## **PLANNING COMMISSION MEETING**

**Wednesday, April 19, 2023 at 7:00 PM**

**SUBJECT:** Comprehensive Plan Amendment, Rezoning

**TO:** St. Francis Planning Commission  
**FROM:** Beth Richmond, Planner  
**SUBJECT:** City Hall Fire Station Site Plan  
**DATE:** 4-12-2023 for 4-19-2024 meeting  
**LOCATION:** South of Bridge Street between Ambassador Blvd NW and Woodbine Street NW (PINs: 32-34-24-34-0009, 32-34-24-34-0010, 32-34-24-34-0011, 32-34-24-34-0012, 32-34-24-34-0013, 32-34-24-34-0014, 32-34-24-34-0015, 32-34-24-34-0016)  
**COMP PLAN:** Public/Institutional  
**ZONING:** B-1 Central Business

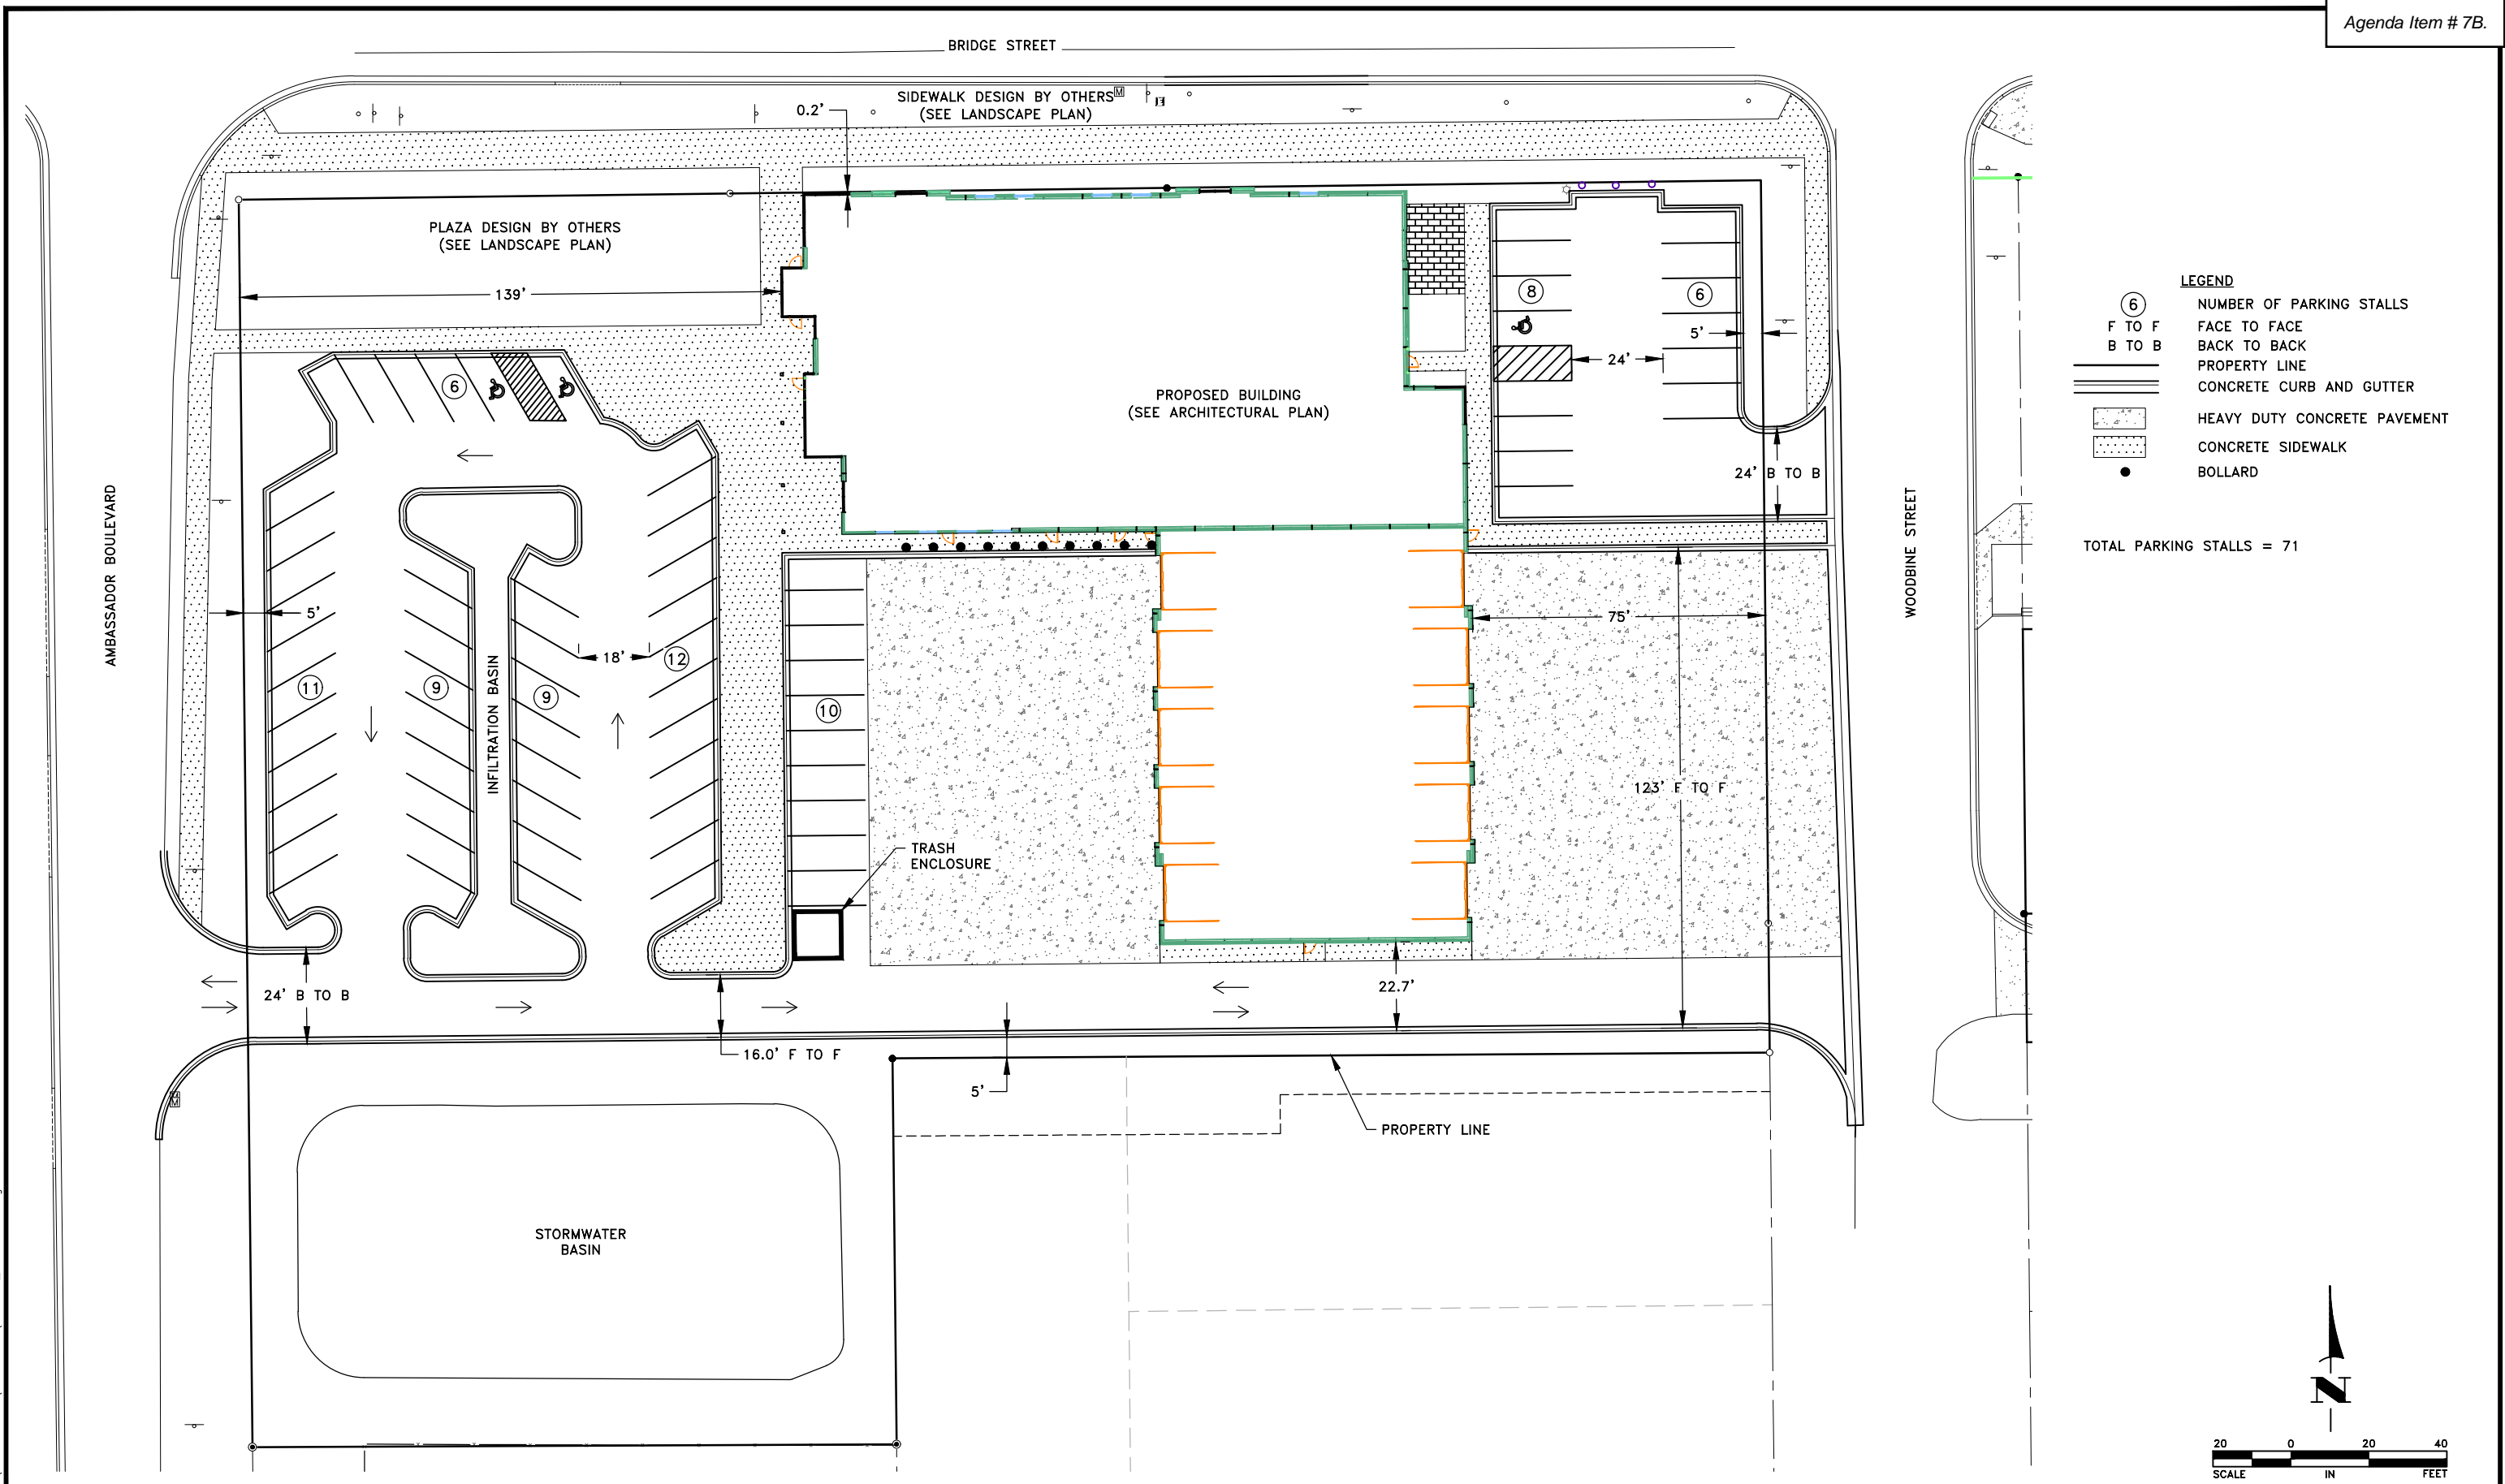
The subject site is located within the Bridge Street corridor and is zoned B-1 Central Business. The intent of the B-1 district is to provide for a mix of uses along the Bridge Street corridor with consideration for pedestrian and bicycle access. In order to create this pedestrian-friendly atmosphere, the Bridge Street Design Guidelines recommended that buildings along Bridge Street be built within 5' of the right-of-way. From this recommendation, the City Code was updated to require setbacks between 0' and 5' from all street yards (front and corner side). The proposed city hall/fire station meets this requirement along Bridge St NW but exceeds this setback range on its east and west sides.

Because the proposed building sits within the front yard setback range established for the Bridge Street corridor, Staff's opinion is that the location of the proposed structure meets the intent of B-1 district and the Bridge Street Design Guidelines. Therefore, no variance is needed for the corner side setback. Staff recommends updating the B-1 Code requirements to clarify this provision in the future.

A 5,000 square foot public plaza is proposed on the northwest corner of the site. This plaza will include a lawn area and paved seating area to be used by members of the public or those visiting or working in the City Hall/Fire Station building. The plaza is intended to serve as an inviting gateway to City Hall from Ambassador Blvd NW and Bridge St NW. Streetscape improvements and plantings along Bridge St NW are proposed which are consistent with the plaza design.

The northern 10 feet of the plaza is located within the County ROW. In the future, the County may request additional ROW for the construction of a roundabout at the Ambassador Blvd NW and Bridge St NW intersection. Reflecting this future roadway alignment, the lawn area is proposed to be located on the west end of the plaza and can be removed or reconfigured as needed. The City will continue to work with the County to determine the future plans for the area.

- A 46-stall public lot on the west side of the site will serve as parking City Hall parking. This parking lot includes angled stalls and will serve one-way traffic in a counterclockwise circulation pattern. Municipal buildings are required to provide 1 parking space per employee on the maximum work shift. For City Hall, the maximum number of employees is 16.
- A 14-stall parking lot on the northeast corner of the site will serve as parking for the Fire Station. This parking lot must be large enough to accommodate parking for the regular monthly trainings that are held for the entire Fire Department. The maximum size of the department is 12 persons.

Because this site will have a significant amount of impervious surface, snow storage has been an important consideration in the development of the site plan. Snow storage will be provided within and along the western public parking lot in the medians and green areas. Snow storage can also take place in the southwest corner of the site near the stormwater pond.

As proposed, evergreen trees make up 13% of the total complement of trees to be planted on the site. Typically, evergreens should make up at least 25% of the required tree mix. The proposed site is located at two intersections and contains limited open space. Due to their shape, evergreens must be planted in areas with ample open space. In order to preserve sightlines around the intersections and provide a mix of trees and other plantings while acknowledging the constraints of the proposed development site, Staff supports the landscaping plan as proposed.

Recent updates to Section 10-73-05 require that uses provide screening along the boundary of any residentially zoned parcel. The parcel to the south, while used for a residential purpose, is zoned B-1 Central Business. While no screening is required, Staff recommends the placement of a fence or other measure along the south property line to reduce the potential for emergency vehicle headlights to shine into the existing home.

- 1. Applicant shall work with Anoka County to determine streetscape and landscape plan for the ROW along Bridge St NW.
- 2. All parking areas shall be located at least 5’ from any lot line.
- 3. Applicant shall address the transparency requirements on all street-facing facades.
- 4. Applicant shall address all comments from Anoka County.
- 5. Lighting
  - a. The applicant shall provide lighting specification sheets demonstrating that all lighting is contained within a cutoff fixture(s).
  - b. All non-public outdoor light fixtures lighting areas other than the building façade shall be set back a minimum of 10 feet from any street right-of-way.

6. Applicant shall install a fence or other similar improvement along the south property line to mitigate any effect of headlights onto the residential property to the south.
7. Applicant shall provide materials demonstrating that all mechanical equipment is adequately screened in a way that is compatible with the design of the site and building.
8. All signage shall meet Code requirements and shall be reviewed through the sign permit process.
9. Other conditions identified during the review process by Staff, the Planning Commission, or the City Council.
